Reference: 17.136r01v05

**Re: The Lakes Hotel – Planning Proposal  
Traffic Impact Statement**

TRAFFIX has reviewed the architectural drawings prepared by Darren Mah Design and now advises as follows.

DRAWING NO.	SK-01-1
DATE	MARCH 2017
DRAWN	DM
SCALE	1:200
REV	B

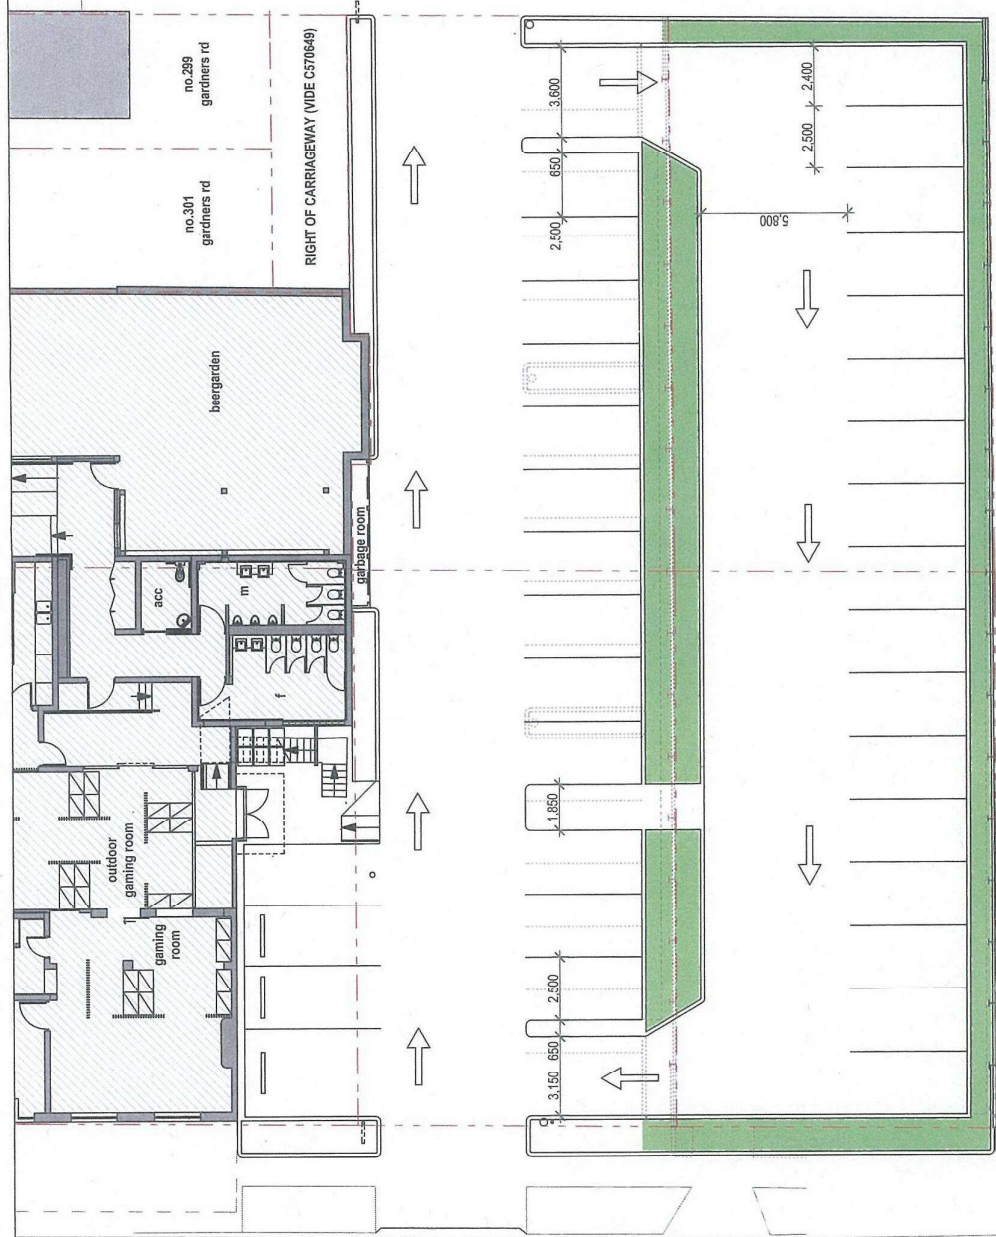
The internal design of the car park, illustrated in the Indicative Concept Plan, has been assessed in accordance with AS2890.1 (2004), with the following noteworthy:

- All parking space dimensions satisfy the minimum requirement of User Class 2 with a space width of 2.5m a space length of 5.4m and aisle width of 5.8m with the exception of one space provided with a design width of 2.4m. This space should be designated a 'small car space' if used by customers or reserved as an employee space (meeting the requirements of User Class 1A –Employee parking).
- The swept path analysis in **Attachment 2** demonstrates that the proposed one-way circulation aisles accommodate a vehicle up to the size of a B99 vehicle.

In summary, the internal design for the Indicative Concept Plan is expected to operate satisfactorily. It is envisaged that any minor amendments required (if any) can be reviewed and undertaken at development application stage once the Planning Proposal is finalised.
